Re: Certificate Amendment for Don Marquis 138 kV Loop #1
Project (certificate granted in Case No. 07-715-EL-BTX)

Amendment

Don Marquis 138 kV Loop #1 Project
(Certificate granted in Case No. 07-715-EL-BTX)

Columbus Southern Power Company

FIGURE 01
SITE VICINITY

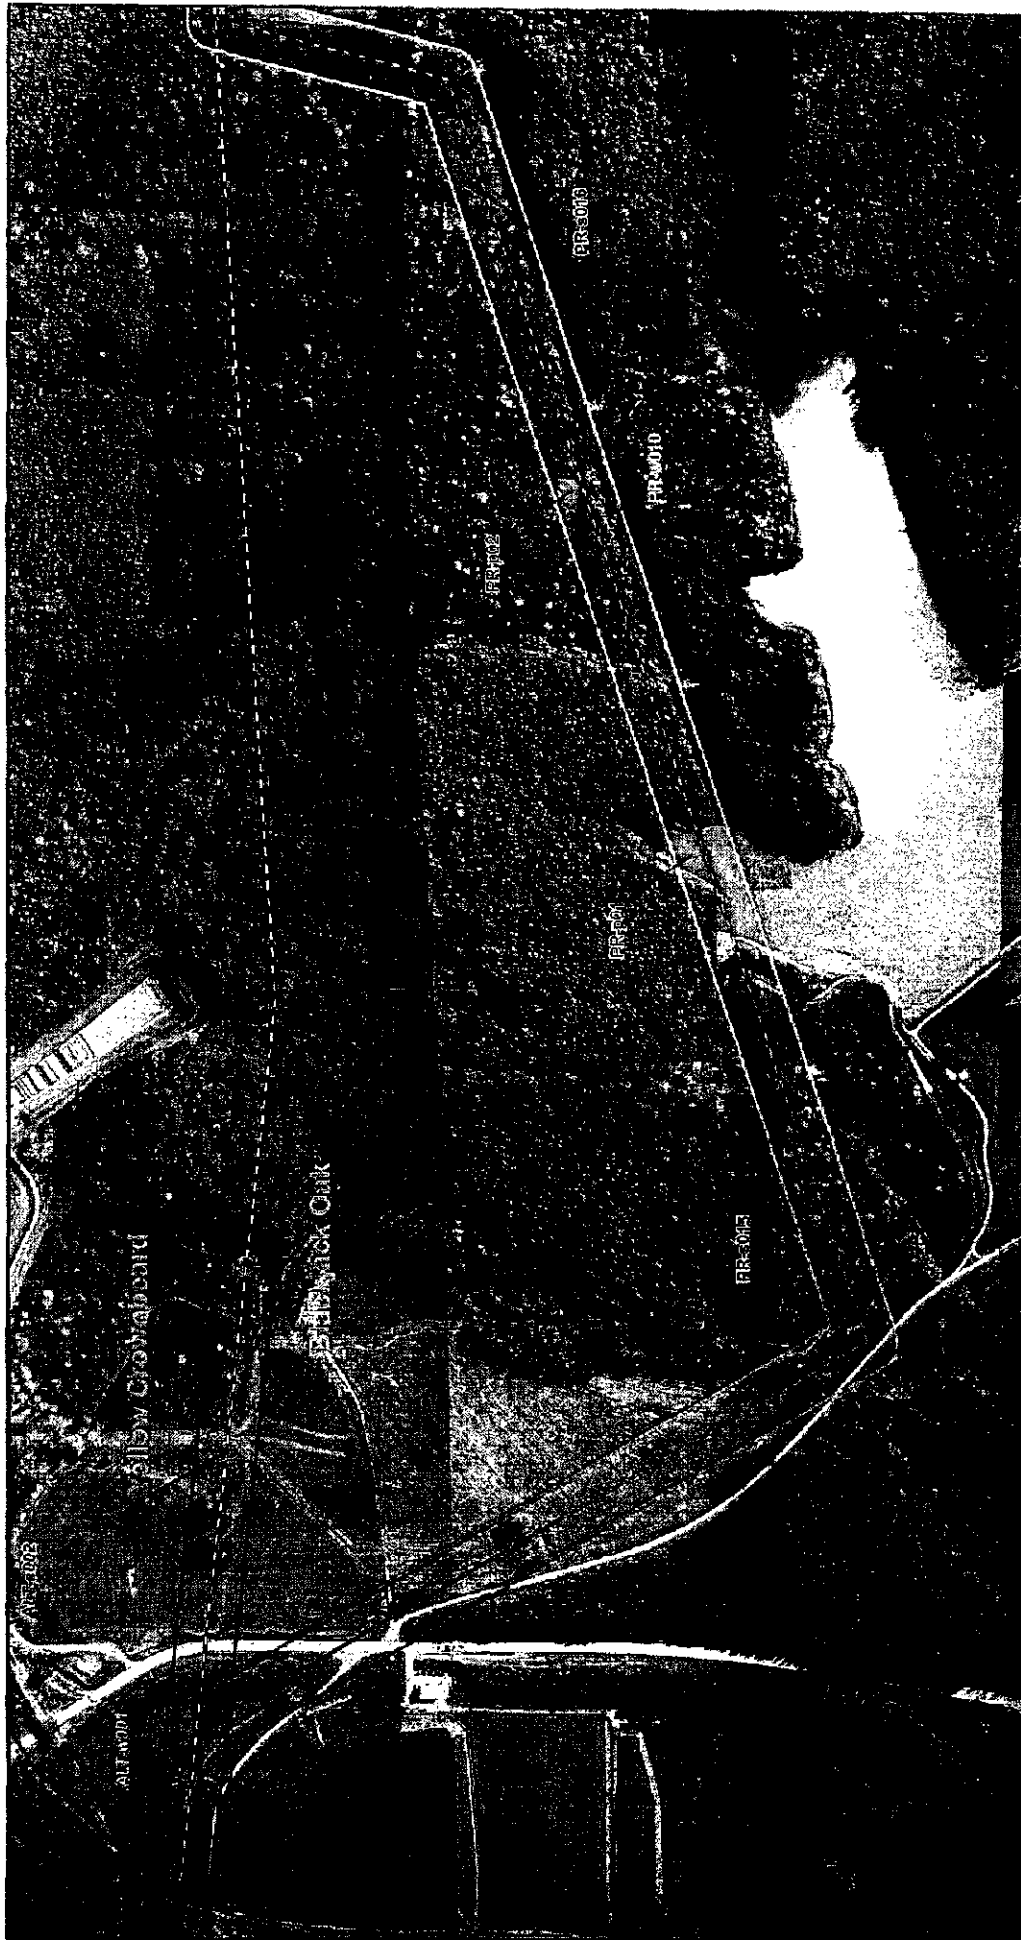
The old Preferred Route that was initially submitted to the OPSB was six miles long. The new Preferred Route is slightly longer at 6.4 miles. The route change occurs on DOE property and affects no other landowners. The line change is a result of the DOE asking AEP to move the proposed line south to parallel an existing transmission line, see Attachment 1.

The old Preferred Route bisected through grasslands and mature deciduous forest, just south of their gun range. The new Preferred Route passes through grassland, young coniferous forest and young deciduous forest. See Figure 1 for the location of the new Preferred Route versus the old Preferred Route.
